| Well Name: CORRAL 23-35 FED COM | Well Location: T25S / R29E / SEC 23 / NWNW / 32.122521 / -103.962806 | County or Parish/State: EDDY / NM |

Sundry ID: 2862073

| Type of Submission: Notice of Intent           | Type of Action: APD Change   |

**Procedure Description:** XTO Energy Inc. respectfully requests approval to make the following changes to the approved APD. Changes include KOP, FTP, LTP, BHL, Proposed total depth, Pool, and dedicated acreage, Formation, Casing Design, Cement Program & Mud Circulation System. APD ID 10400098908; Well API: 30-015-56884 FROM: TO: KOP: 91' FNL & 287' FWL OF SECTION 23-T25S-R29E 100' FNL & 725' FWL OF SECTION 23-T25S-R29E FTP: 100' FNL & 660' FWL OF SECTION 23-T25S-R29E 100' FNL & 725' FWL OF SECTION 23-T25S-R29E LTP: 100' FSL & 660' FWL OF SECTION 35-T25S-R29E 100' FSL & 725' FWL OF SECTION 35-T25S-R29E BHL: 50' FSL & 660' FWL OF SECTION 35-T25S-R29E 50' FSL & 725' FWL OF SECTION 35-T25S-R29E The proposed total depth is changing from 24283' MD; 8015' TVD to 24936' MD; 9440' TVD. The Pool is changing from WILLOW LAKE; BONE SPRING, SOUTHEAST to WILLOW LAKE; BONE SPRING, SOUTHEAST & CORRAL CANYON: BONE SPRING, SOUTH. The Dedicated acreage is c

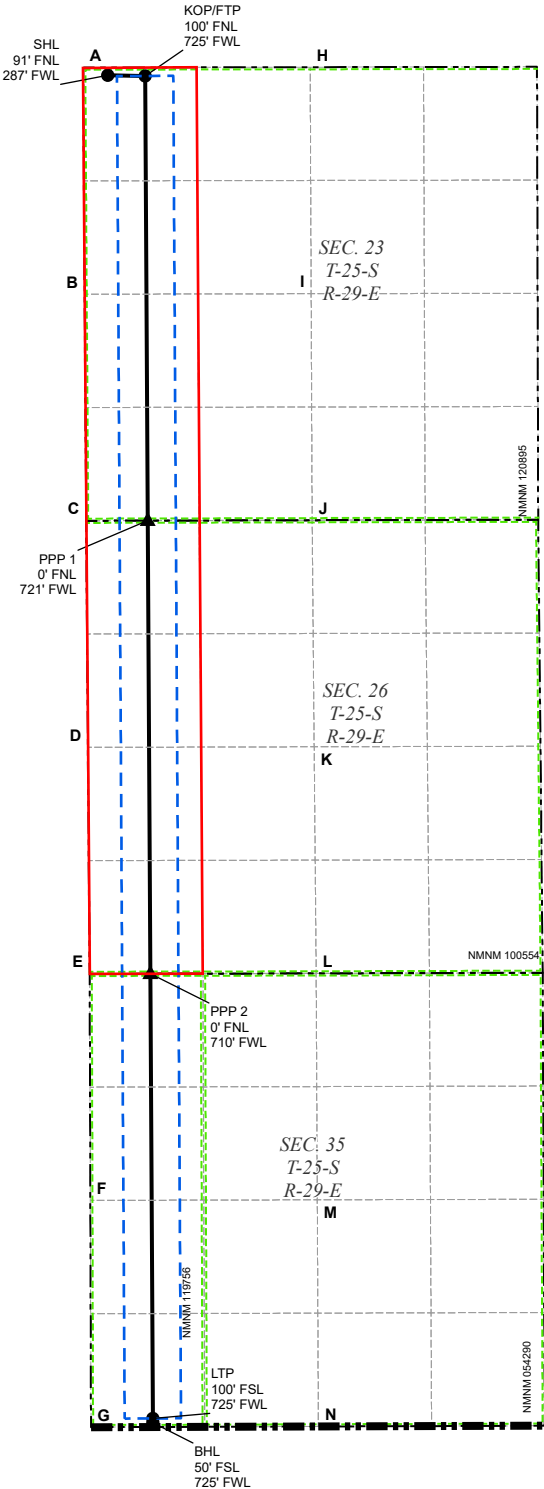
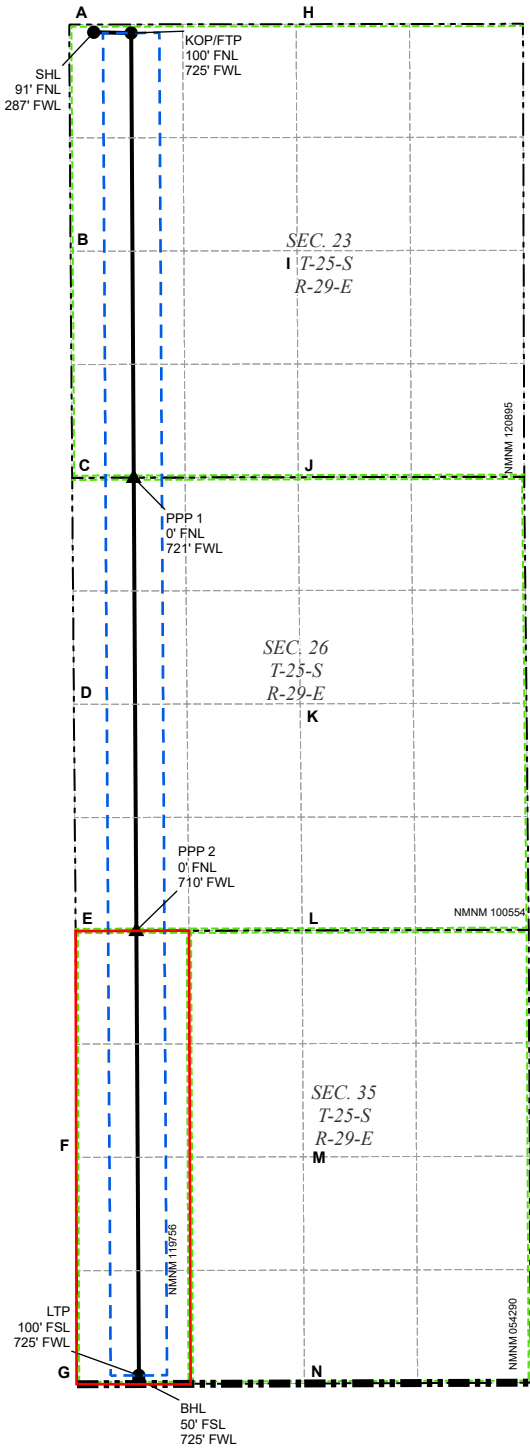
KOP: 91' FNL & 287' FWL OF SECTION 23-T25S-R29E 100' FNL & 725' FWL OF SECTION 23-T25S-R29E  
FTP: 100' FNL & 660' FWL OF SECTION 23-T25S-R29E 100' FNL & 725' FWL OF SECTION 23-T25S-R29E  
LTP: 100' FSL & 660' FWL OF SECTION 35-T25S-R29E 100' FSL & 725' FWL OF SECTION 35-T25S-R29E  
BHL: 50' FSL & 660' FWL OF SECTION 35-T25S-R29E 50' FSL & 725' FWL OF SECTION 35-T25S-R29E

The Pool is changing from WILLOW LAKE; BONE SPRING, SOUTHEAST to WILLOW LAKE; BONE SPRING, SOUTHEAST & CORRAL CANYON; BONE SPRING, SOUTH.

The Dedicated acreage is changing from 640 to 320 & 160.
